Chinatown Public Health Center Renovation

Civic Design Review Phase III
Presentation

February 26, 2024

CDR PHASE 2 CONTINGENCIES

2. Exterior Signage – Mason Street Entry

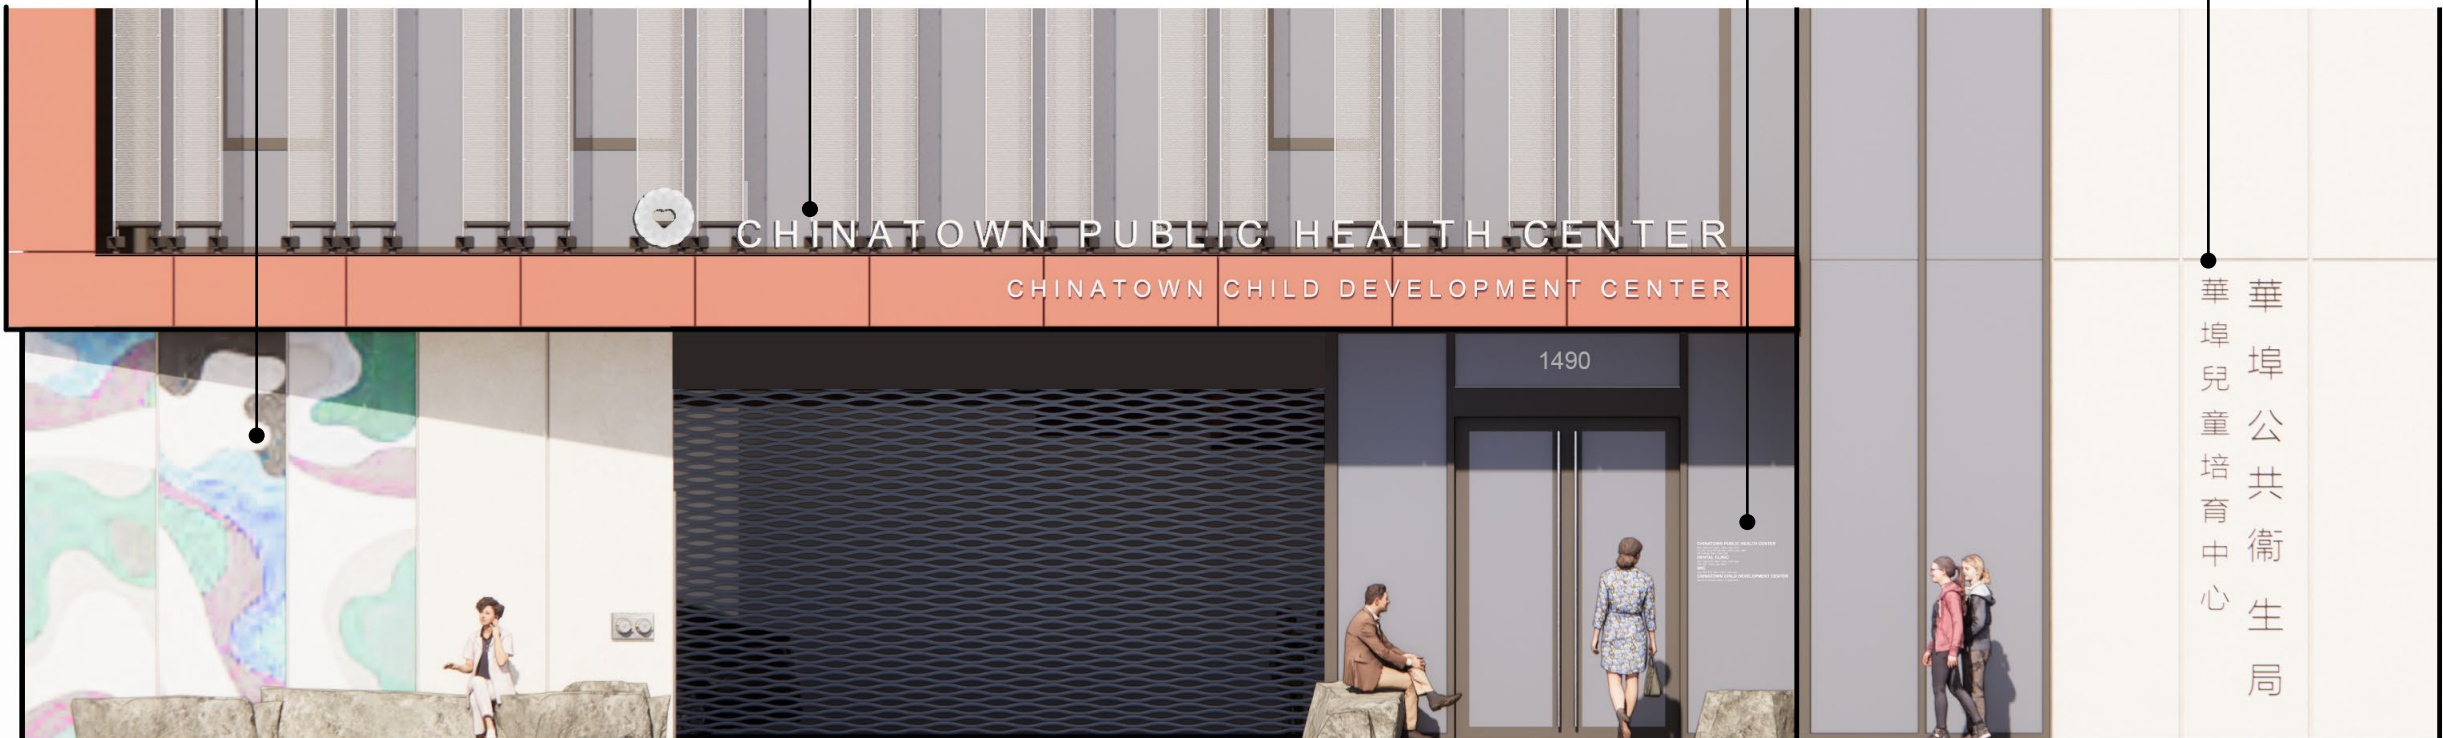
“Characters that name the clinic be more human scale and are down lower on street level and will have bilingual version of English and Chinese.”

7 [BS] BUILDING EXTERIOR SIGN - FRONT VIEW
1" = 4"

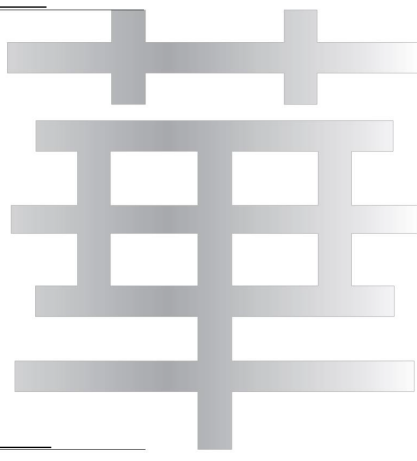
“Characters that name the clinic be more human scale and are down lower on street level and will have bilingual version of English and Chinese.”

Pin-mounted flush to front of canopy
Or building façade

Pin- Mounted flush to building
façade

Broadway Façade:
Brushed Stainless Steel

Mason St. Façade:
Dark Bronze Finish
